TECHNICAL SERVICE BULLETIN

Single Rear Wheel Only - Boom/Hum/Moan Noise From Rear While Driving At Highway Speeds

22-2271
06 July 2022

This bulletin supersedes 22-2175.

Figure 1

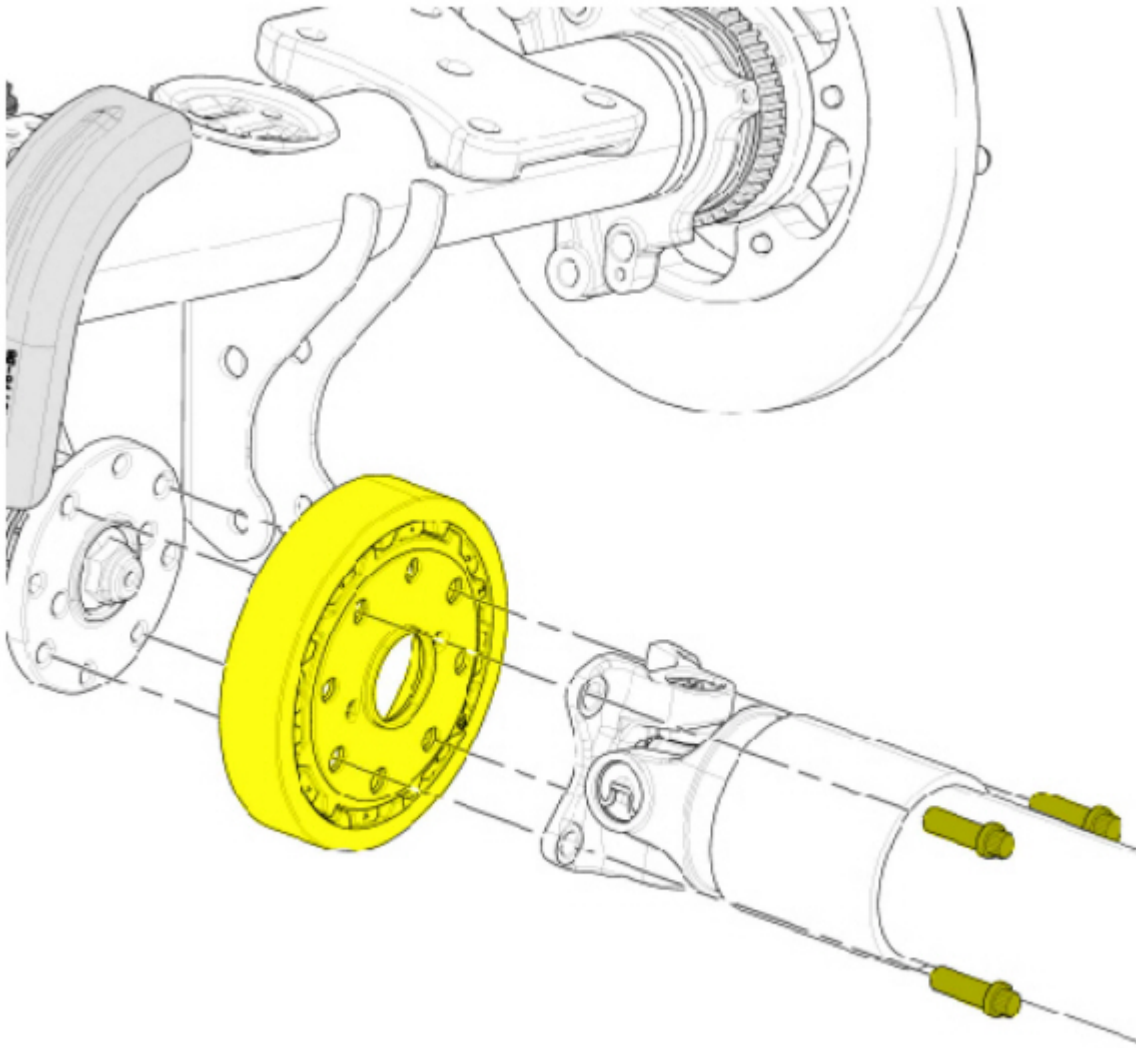
6. Inspect the pinion flange to driveshaft mating surface for any debris or excessive rust and clean as necessary.
7. Install the driveshaft torsional damper on the axle pinion flange. (Figure 1)

8. Align the index mark on the driveshaft and rear drive pinion flange and reinstall the driveshaft. Make sure the driveshaft fits securely over the raised flange on the torsional damper.

(1). Apply Loctite 263 to each of the 4 cleaned bolts. (Loctite to be applied in the engagement area, first 7 threads) Install the driveshaft attaching bolts and tighten to 115 Nm (85 lb-ft). Refer to WSM, Section 205-01. (Figure 1)
